# TIMING COVER VENT AND DRAIN HOLES

At approximate engine No. L.313838 ("FE" Sedans) and Engine No. U.313840 ("FJ" Commercial) the oil drainage from the timing gear cover was improved to reduce the oil level in the cover and thereby minimise the possibility of oil leakage from the timing cover oil seal. At the same time, a vent hole was added to the front face of the cylinder block and engine support plate. In order to achieve improved oil drainage, the following changes have been introduced in production:--

Fig. 1

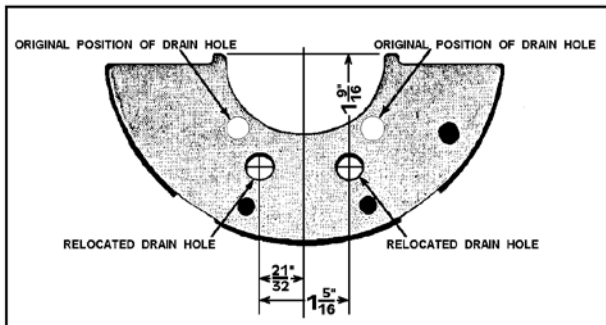
1. Oil drainage holes in the front main bearing cap have been lowered by approximately 1/2 in. (see Fig. 1).
2. A vent hole 1/2 in. dia. added to front face of cylinder block beneath the camshaft bearing bore adjacent to a line taken from the camshaft and crankshaft centre lines (see Fig. 2).

Fig. 3

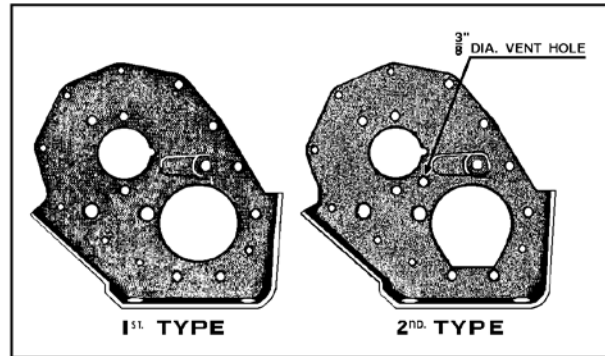
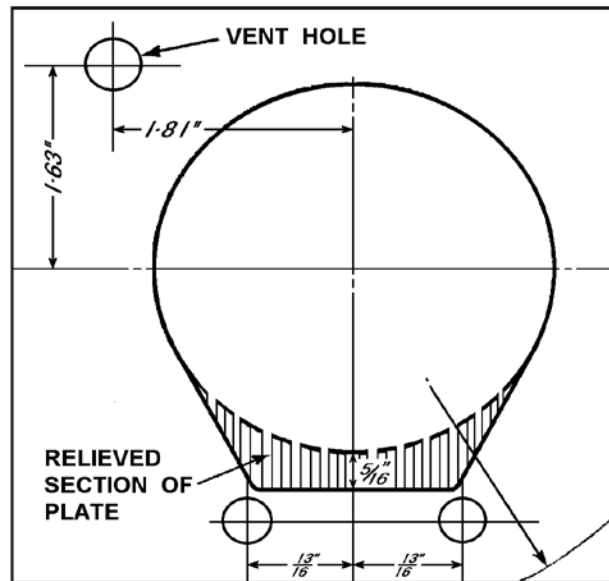
3. A revised type Engine support Plate ("FE"), Part No. 7412006, and gasket, Part No. 7412002, and support plate ("FJ"), Part No. 7412004, and gasket, Part No. 7412003, introduced to suit venting and re-located holes (see Figs. 3 and 4).

Fig. 5

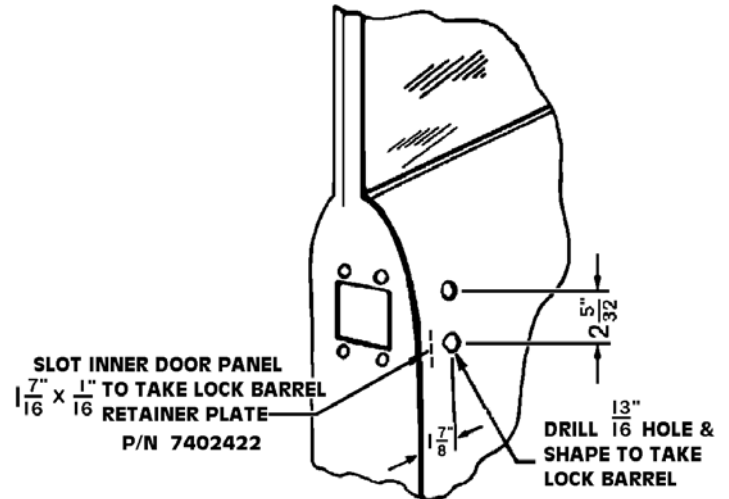
- (1) The removal of the four bolts which attach the lock cover plate and lock to the door pillar face.
- (2) The drilling of a  $\frac{13}{16}$  dia. hole and filing of edge to accommodate the irregular shape of the lock barrel (see Fig. 5).
- (3) The slotting of the door pillar facing to receive the lock Barrel retainer plate, Part No. 7402422.

Fig. 1

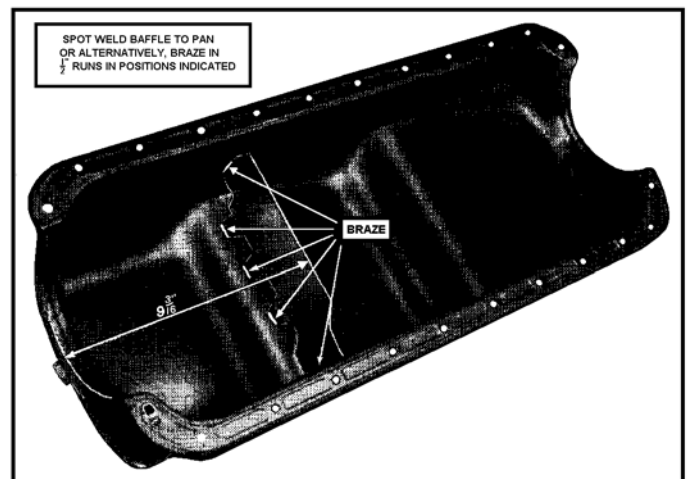
1. Raise the vehicle and place it on jack stands.
2. Drain the oil pan, remove the engine front splash pan and remove the engine breather tube assembly from the push rod cover and oil pan.
3. Remove the pitman arm attaching nut, withdraw the pitman arm and push the steering connecting rod assembly to one side.
4. Remove the oil pan attaching screws and remove the oil pan.
5. Thoroughly clean all traces of oil and sludge from oil pan.
6. Locate baffle in oil pan  $9\frac{3}{16}$  in. from extreme rear end of the pan, with the flanges facing the rear and spot weld in position (Fig. 1).

Fig. 1

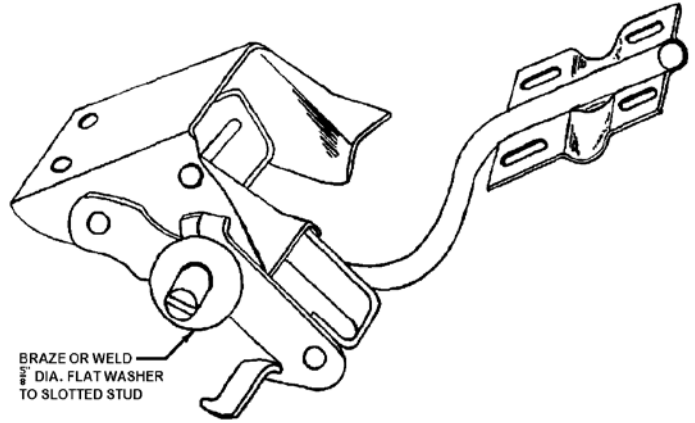
- (1) Remove the hinge spring from the hinge.
- (2) Straighten the pivoting links and re-locate them in correct relationship to each other prior to tightening rivets where necessary.
- (3) Locate and weld 5/8 flat washer over and to the special slotted stud as in Fig. 1.  
*Note:* Protect Paint finish from becoming damaged by packing wet insulation around the weld location.
- (4) Replace the hinge spring and touch up paint finish if required.

Fig. 1

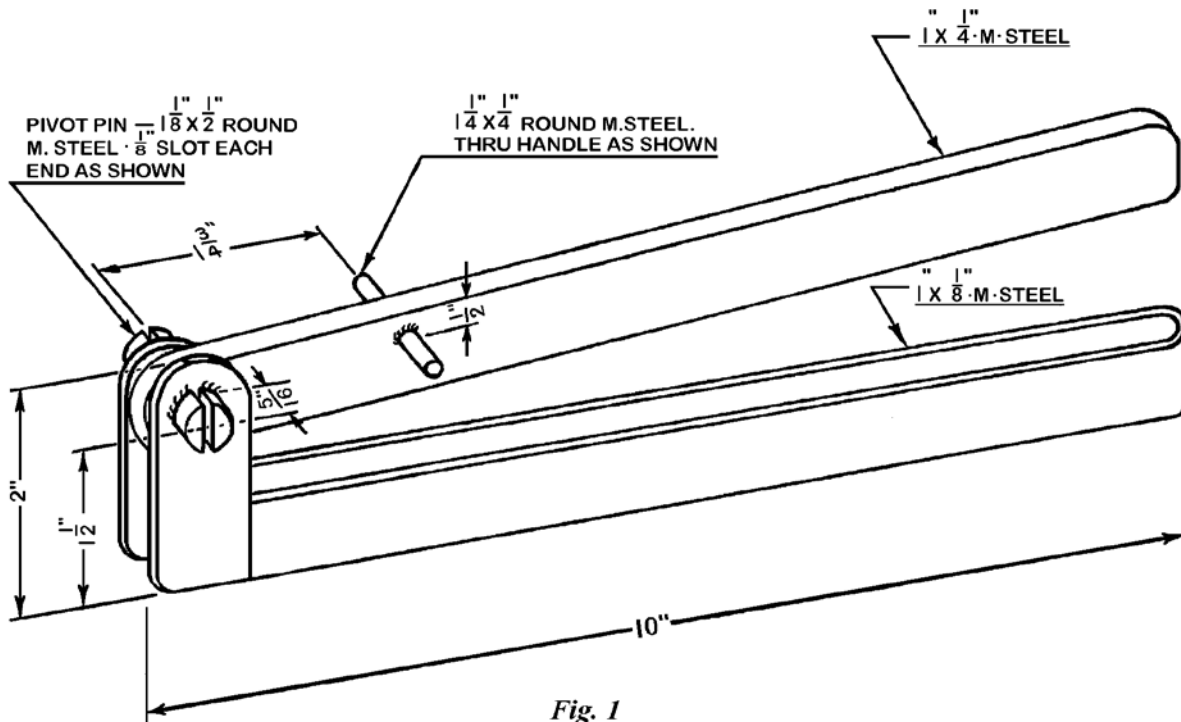
The installation of the trunk lid hinge spring is normally carried out by means of a wire loop placed over the hooked end of the spring, following the spring engagement in the slotted pivot arm. However, requests for a tool from some operators who perform the operation more frequently than others, has resulted in the development of a tool (see Fig. 1) which, under test, has proved effective.

Fig. 4

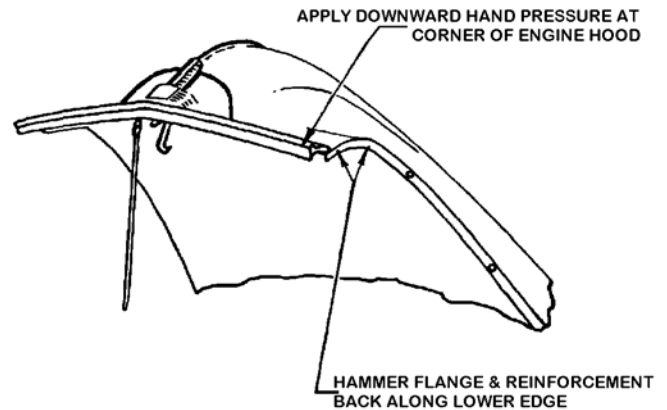
When such a condition necessitates the re-forming or shaping of the forward contour of the Engine Hood this can be achieved by raising the Engine Hood and hammer setting the hood flange and reinforcement at locations shown in Fig. 4.

Fig. 1

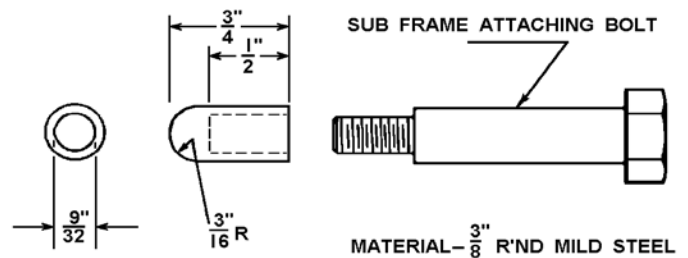
The operation of replacing or entering the bolt can be simplified and damage prevented by fabricating a small metal protective cap shaped like the nose of a bullet to fit over the threaded end of the bolt (see Fig. 2).

**Note:** If for handling reasons or precaution against the loss of because of its size, the  $\frac{3}{4}$ " dimension can be increased to any desired length.
